80 Charlotte Street

— 05 Conclusion

This minor material amendment application seeks to complete the demolition of the original 1960's post office building due to the conditions of the existing structure. The additional demolition sought results in amendments to the facades which have been discussed at the pre-application stage with Camden officers.

Proposed Whitfield Street elevation

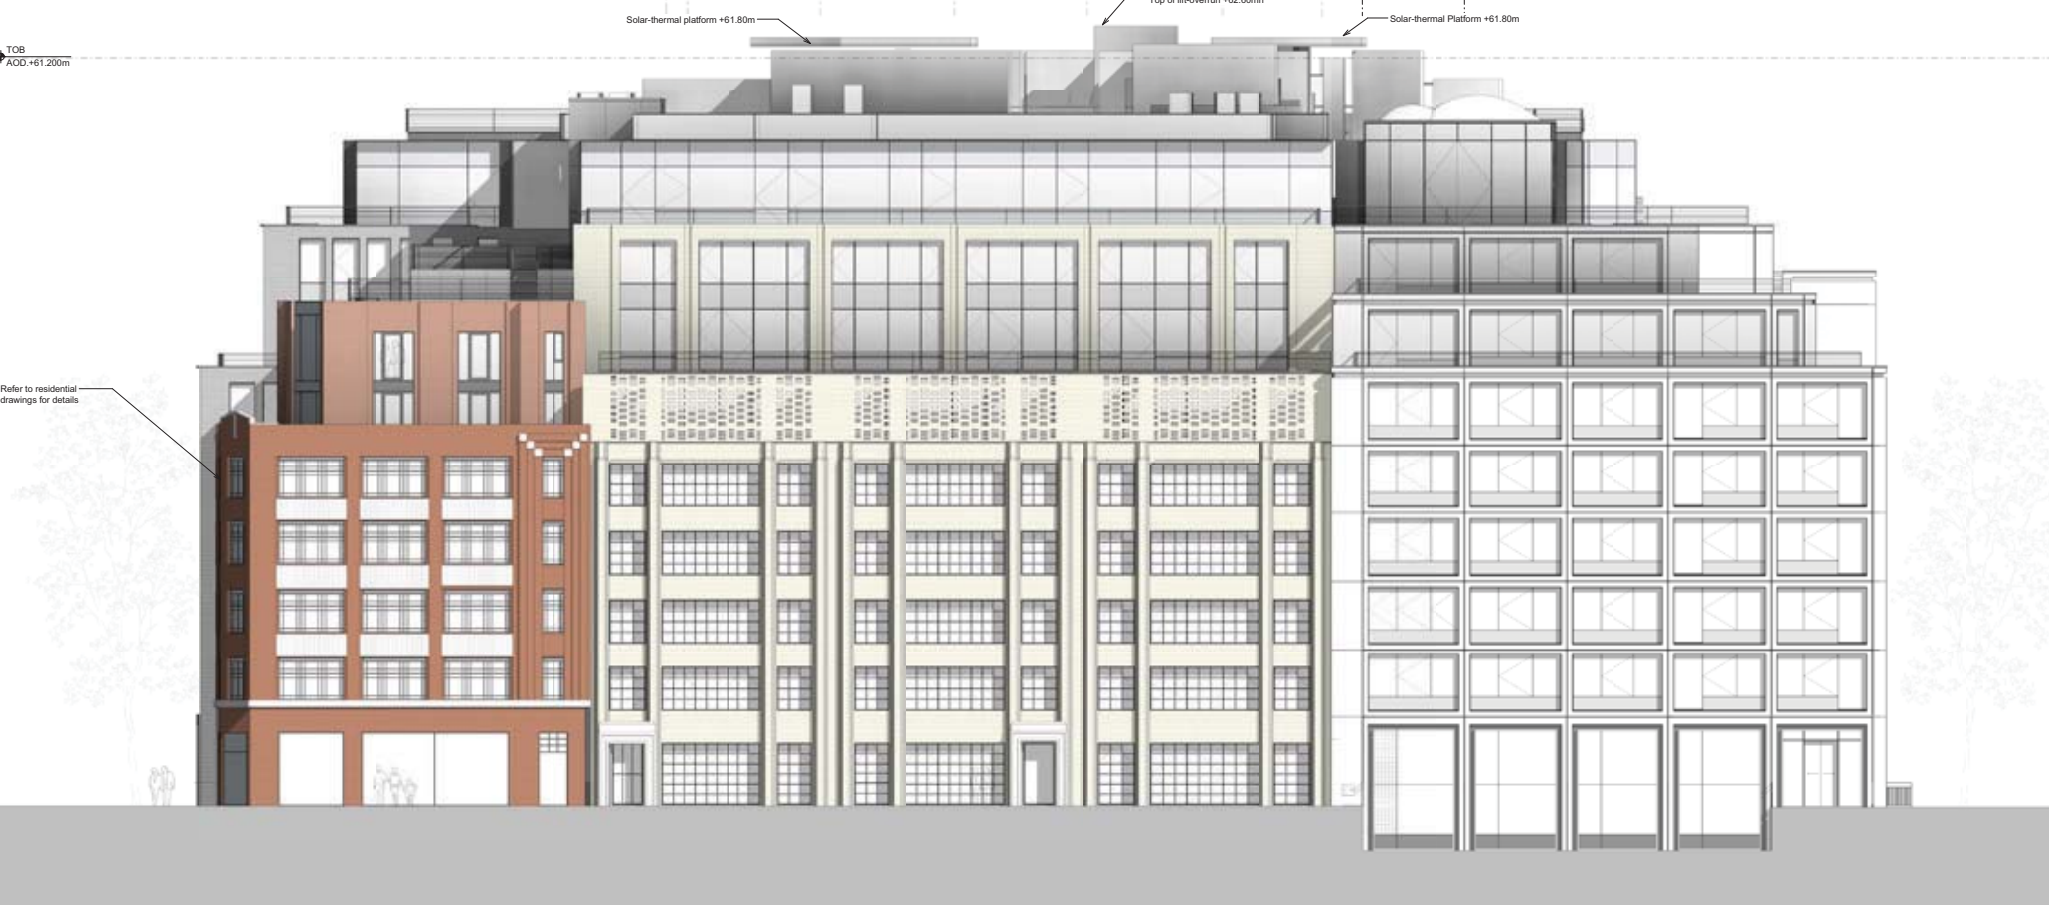
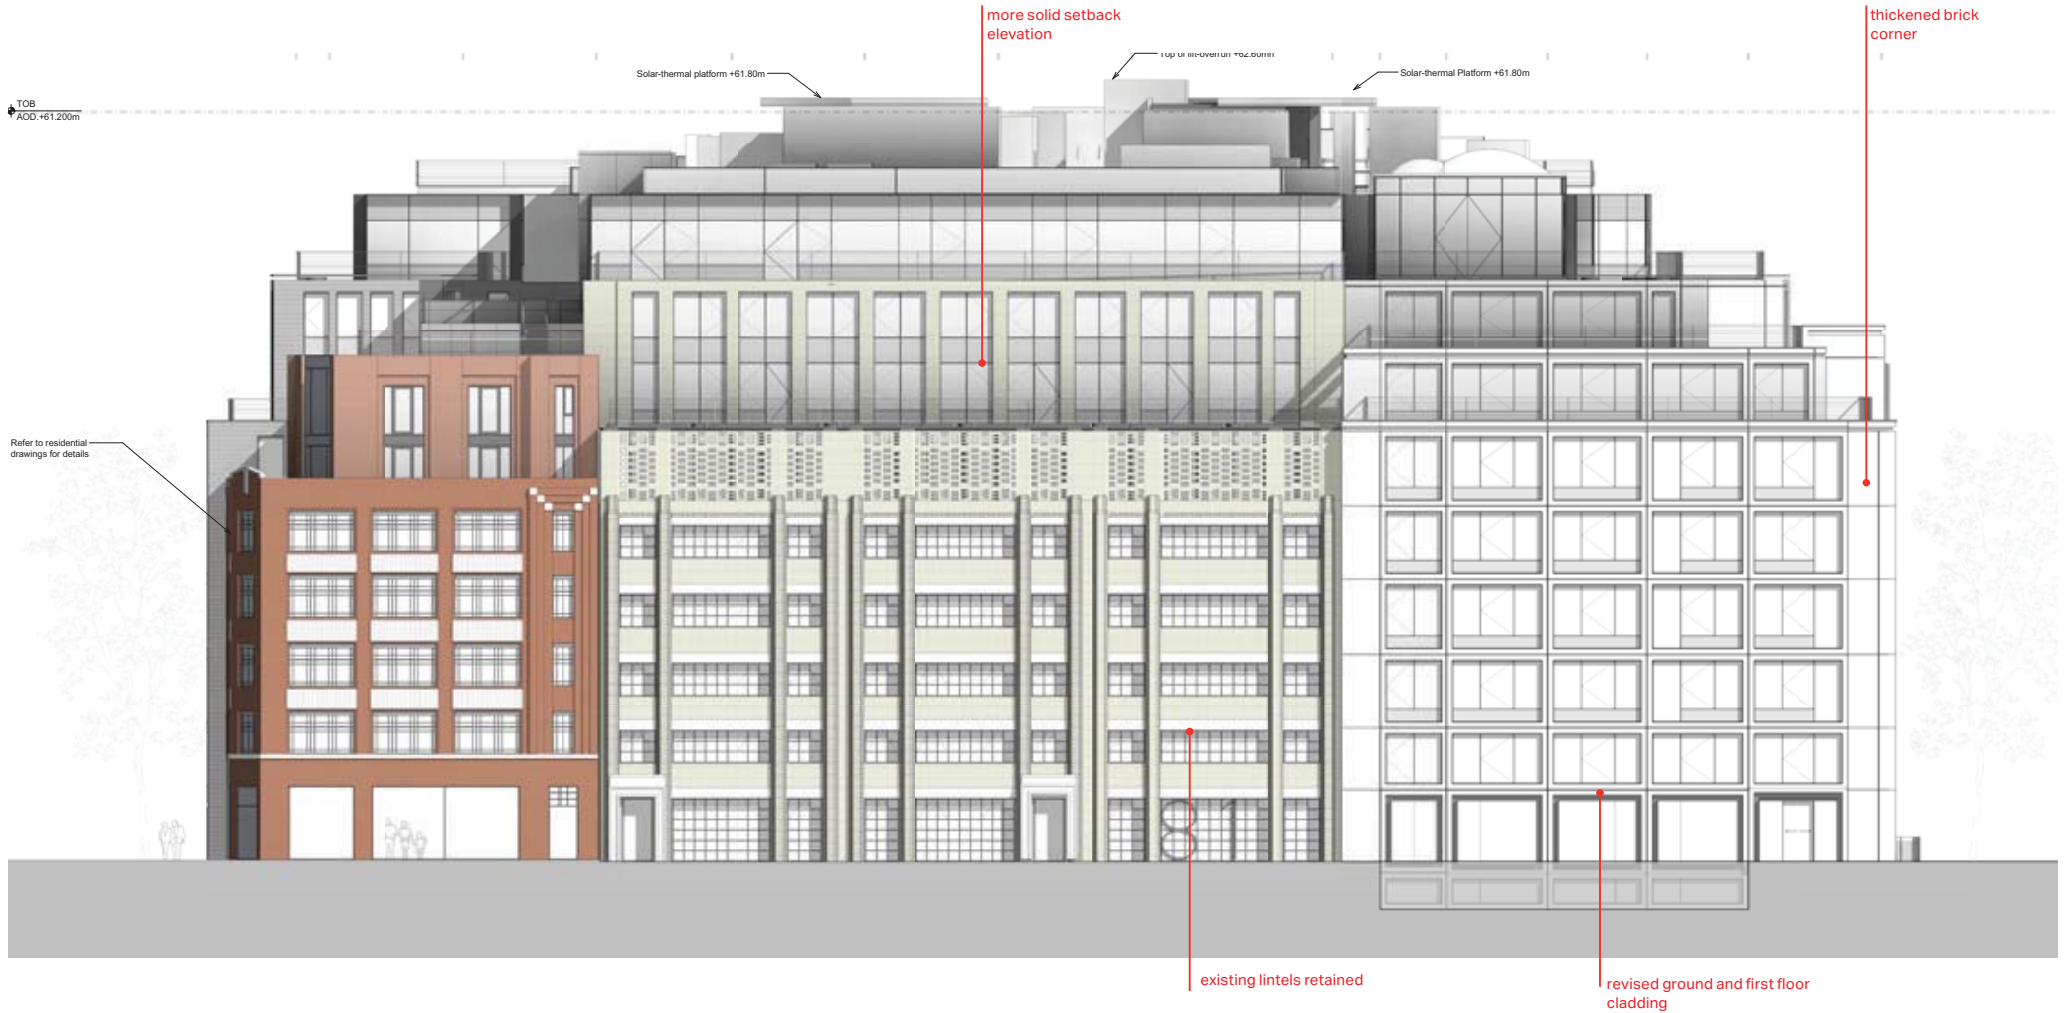
Revised Whitfield Street elevation following the new metric grid and reorganised lower ground, ground and first to fifth floor.

- The new ground floor elevation at the corner with Howland Street narrows the first floor expression to maintain the consented 'tall' ground
- The retention of the existing lintels to the retained façade of No.81 Whitfield Street, the consented scheme removed the existing lintels from first floor to fifth floor.
- The set back cladding above the retained facade is revised to a more solid and vertical elevation

Proposed Chitty Street elevation

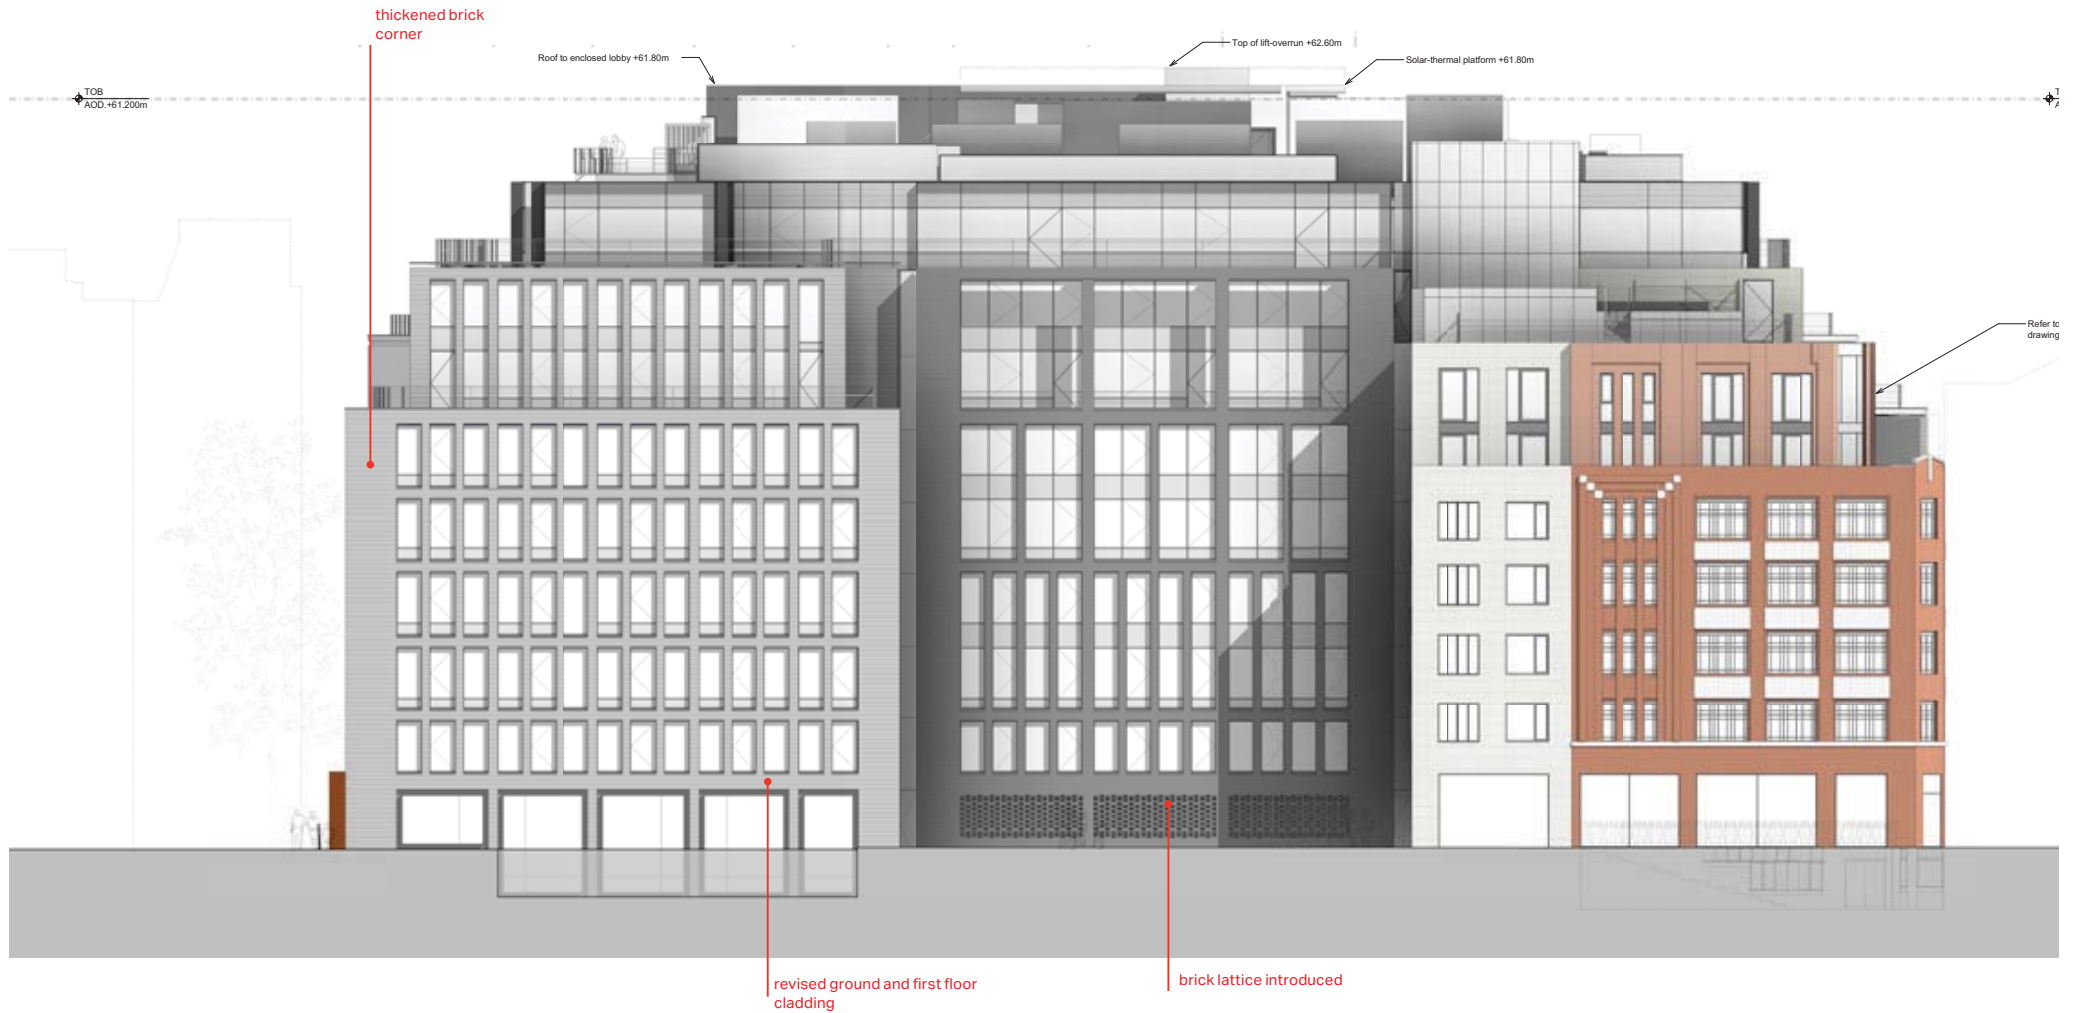
Revised Chitty Street elevation indicating the new metric grid and reorganised lower ground, ground and first to fifth floor.

- Introduction of a brick weave to the back of the pocket park to maintain the impression of solidity and controls views to and from the offices behind
